416 Summit Ave East

Administrative Design Review EDG Packet | Project #3026903 | October 5, 2017 **DRAFT**

DEPARTURE PLAN DIAGRAM

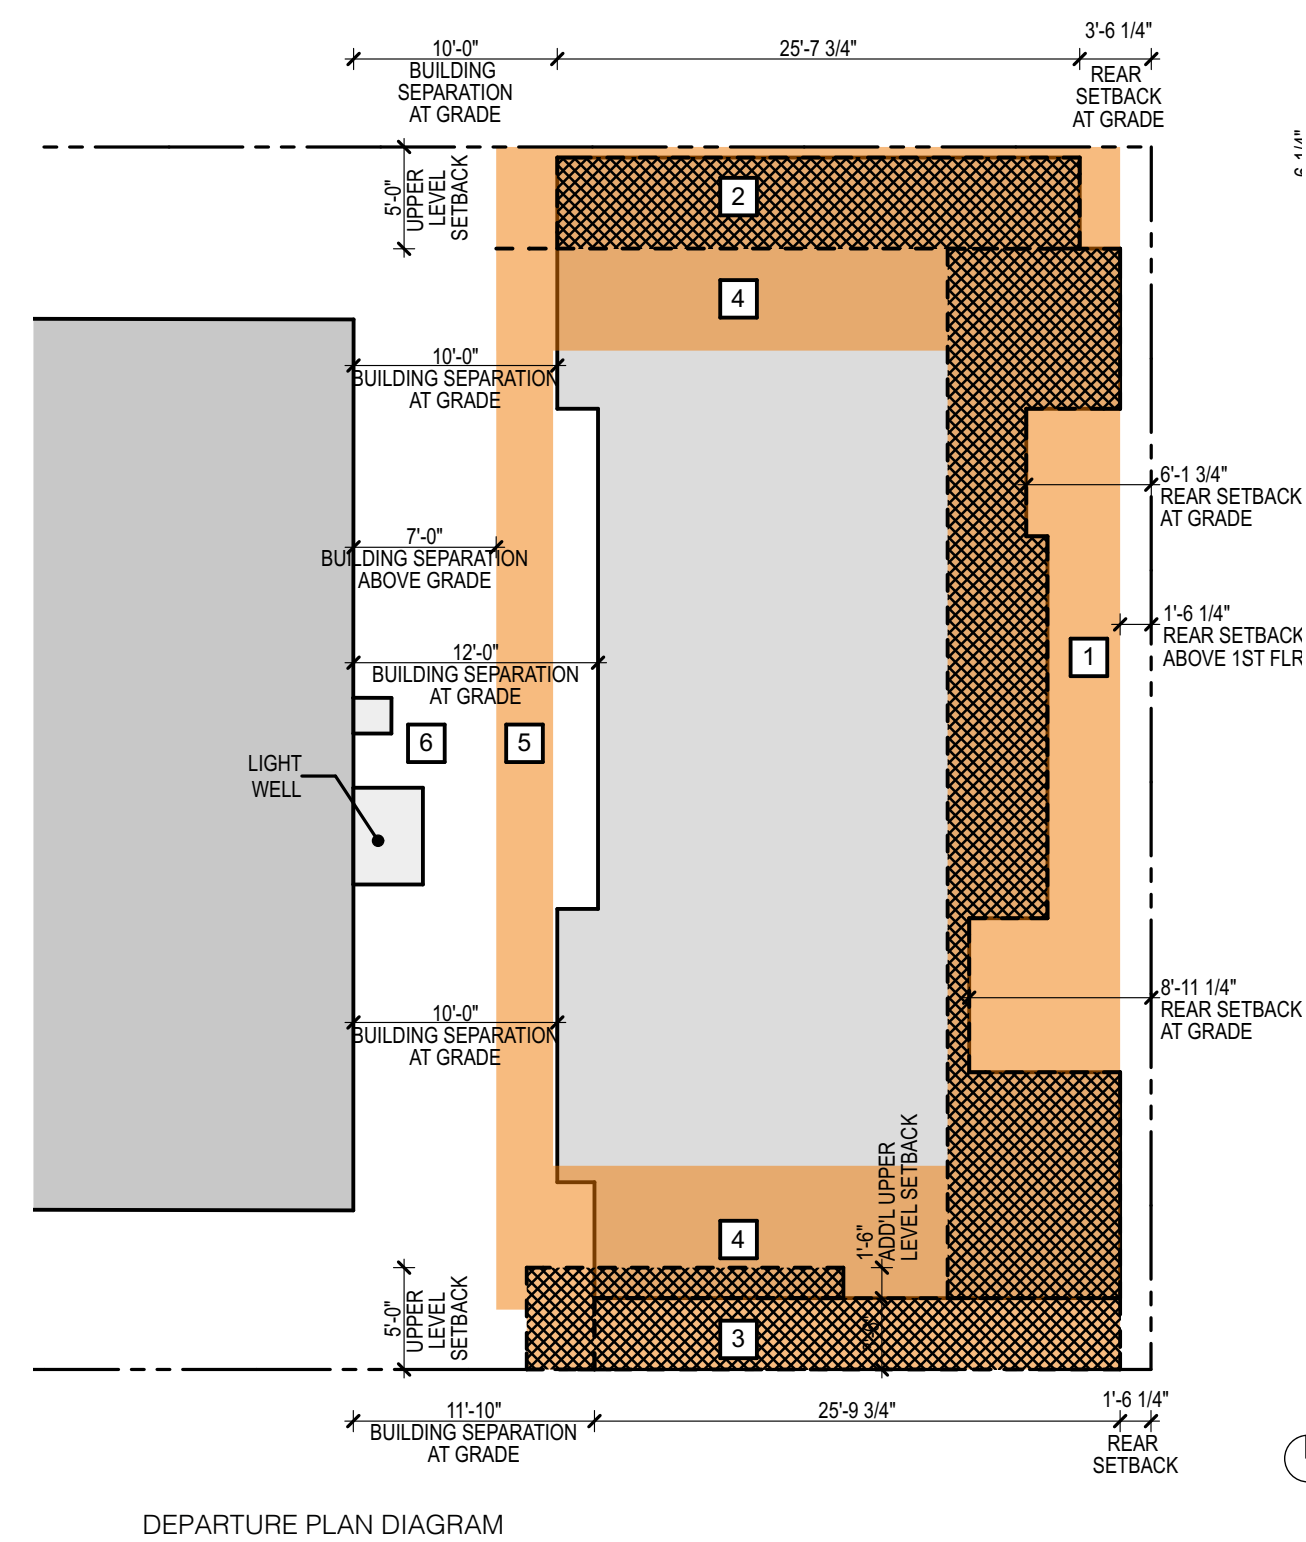
4. Building Separation: The overhang resulting from the requested departure, as well as the level 2 rear balcony, appear to essentially enclose the ground level amenity space and restrict access to daylight.

Staff would be more inclined to support the departure request if the amount of intrusion was reduced to the amount of the rear setback and the overhang occurred above the level of the parapet of the existing Oriana Apartment building.

5. Departure - rear setback: Staff was open to the requested departure from rear setback requirements provided that there is a high level of transparency and/or porosity along the alley, and the design of the amenity space and entry is resolved.

This framing concept appears to shift the perceived bulk of the building closer to the rear property line, negating the rationale of the requested departure. Staff recommends eliminating the solid railing at the second level and solid parapet at the roof level to increase the perceived setback.

e. In response to public comment, Staff strongly encourages increasing the building separation by eroding away the lower two levels of the proposed development in a manner that responds to the existing Oriana Apartment buildings. Staff would be more inclined to support a requested departure from reduced rear setback requirements if a larger common amenity space is provided. (PL1-B-2, DC2-A-1, DC3-C-2)

f. Staff is inclined to support the requested departure from side setbacks above 42-feet provided that sufficient modulation and secondary architectural features are incorporated to reduce the perceived height, bulk and scale of the proposed development, and achieve a better fit with the existing, older residential context. (DC2-A-2, DC2-C-1, DC2-C-3)

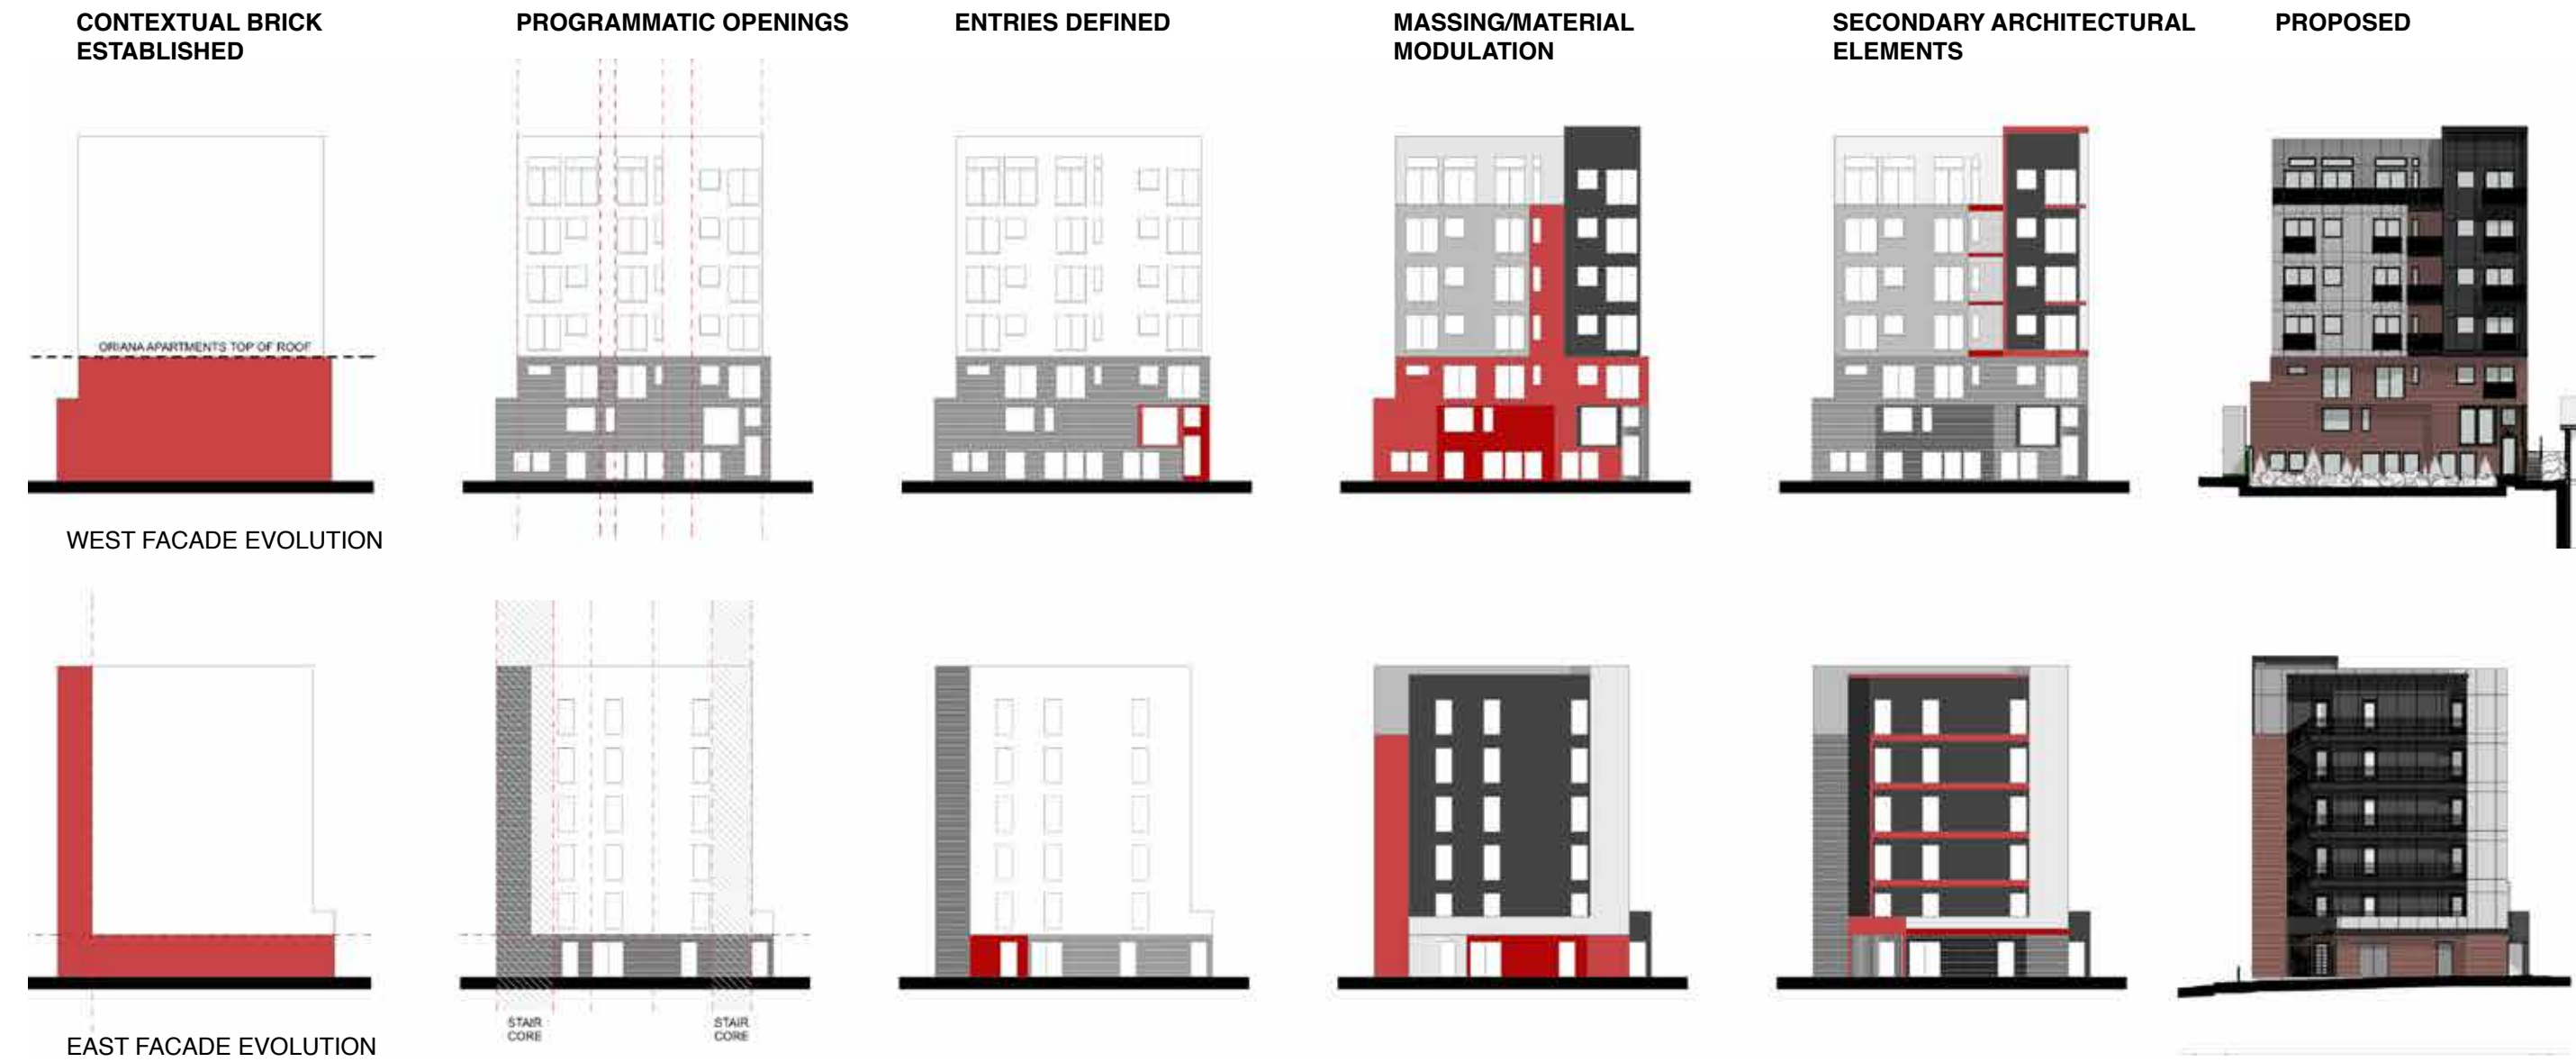
11. Trash: Staff requested additional information regarding trash storage, circulation, and service. Staff does not support trash circulation occurring through amenity space.

Closeup of entry at alley from EDG

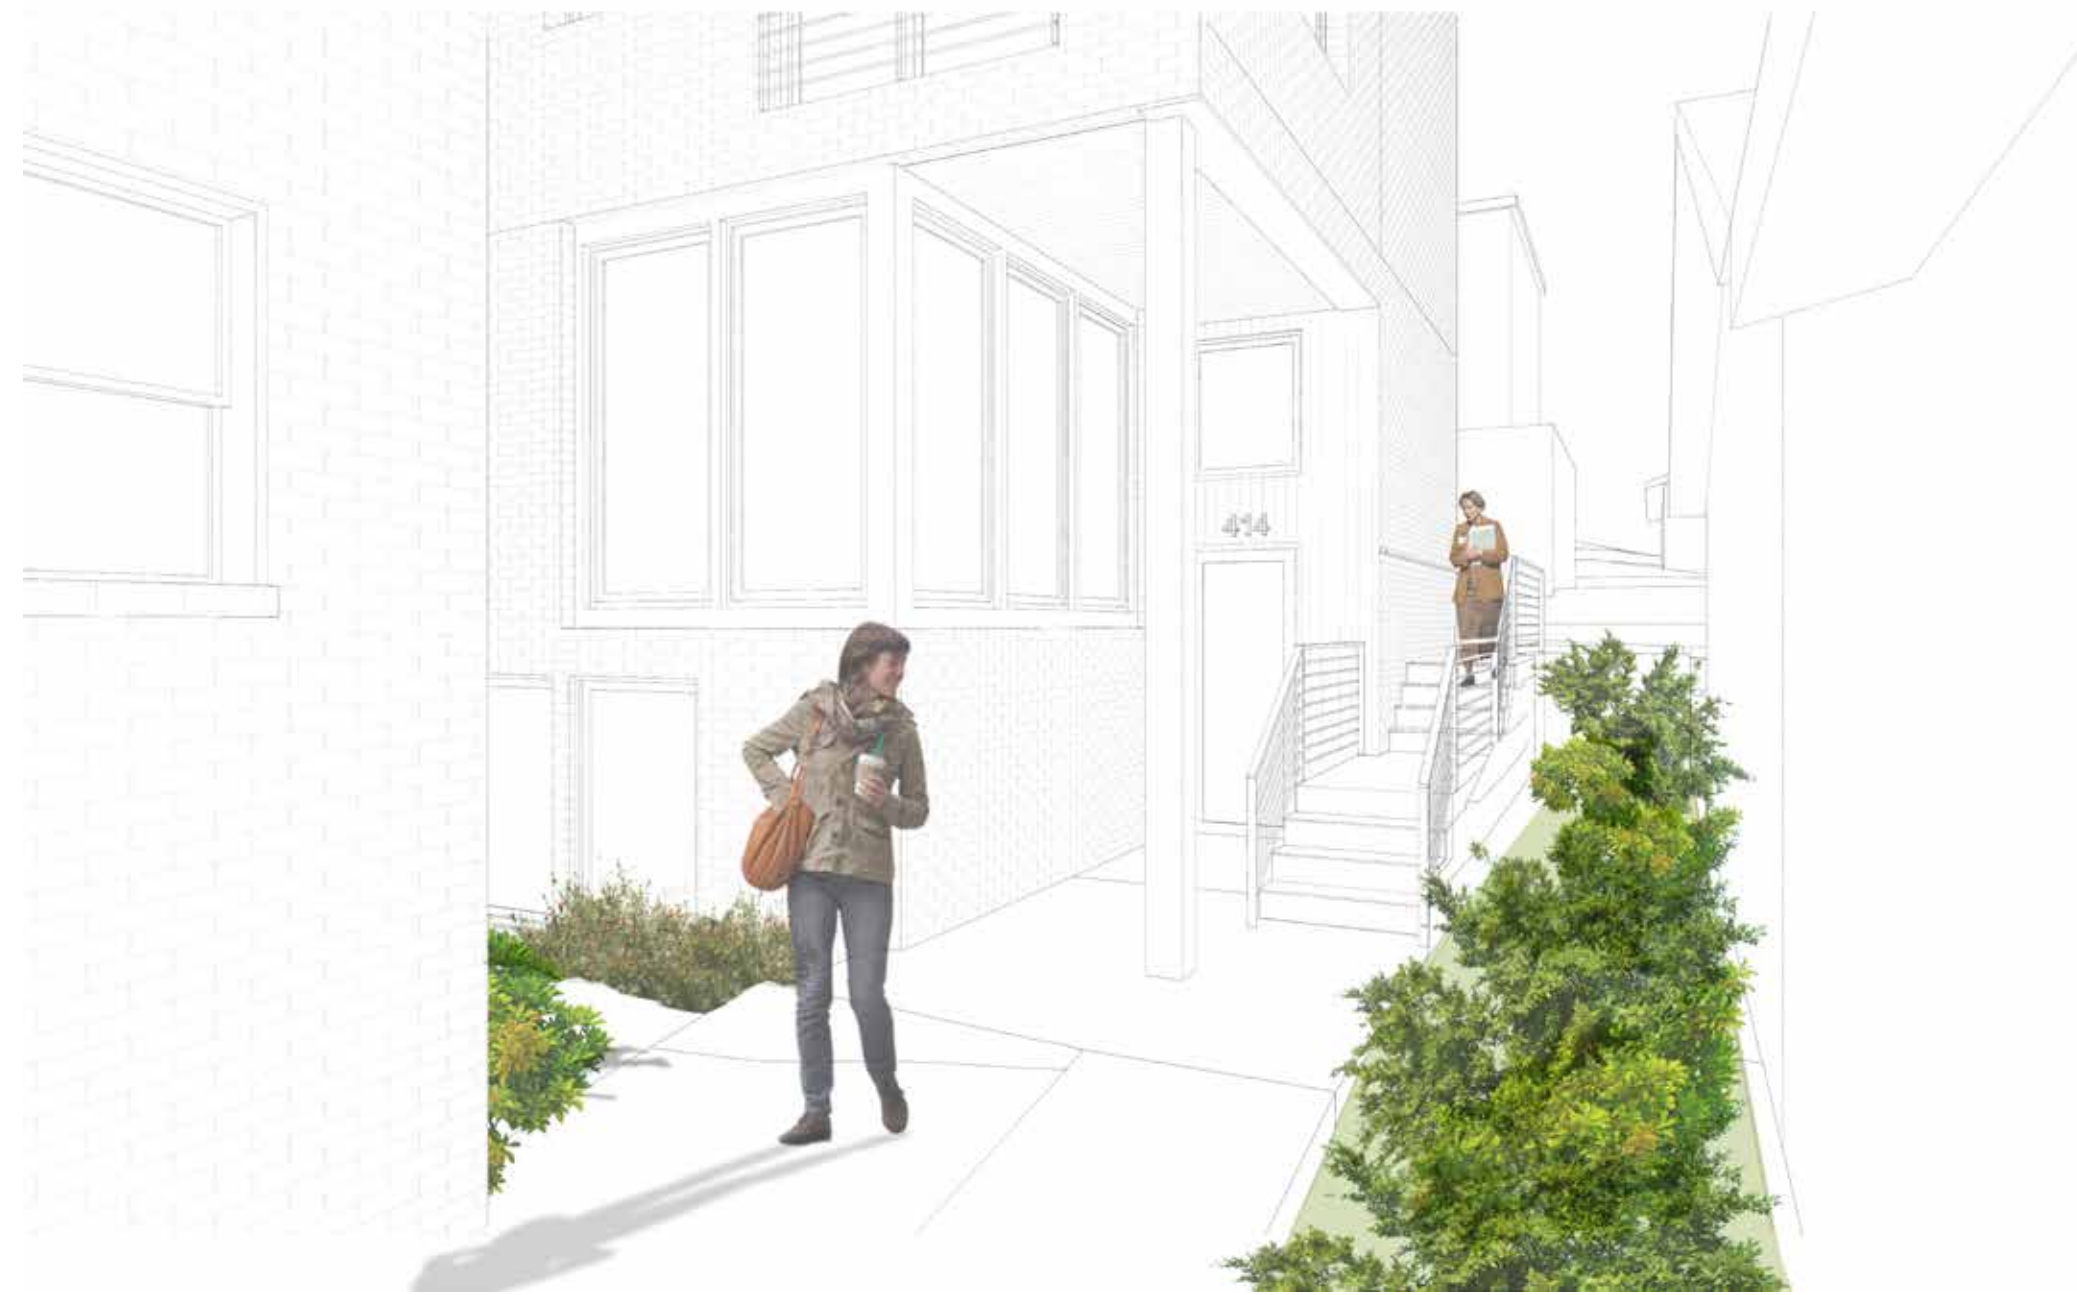
5. Departure - rear setback: Staff does not support the design of the entry as proposed. There lacks an appropriate hierarchy, the individual entry to the ground-level SEDU appears to have more prominence than the lobby entry. Staff has prioritized Design Guidelines PL3-A-1 and PL3-A-2, which state common entries and lobbies should be welcoming, obvious, and identifiable to visitors. The proposed fence surrounding the entry does not help meet these guidelines.

8. Circulation: Staff questions the feasibility of the ramping and stair, particularly how the stair to the amenity space meets the landing.

Staff does not support the proposed resolution as it complicates the entry experience. While the general location is fine, and the increased ground-level setback is supported, the entry should provide direct access to the lobby or lobby level.
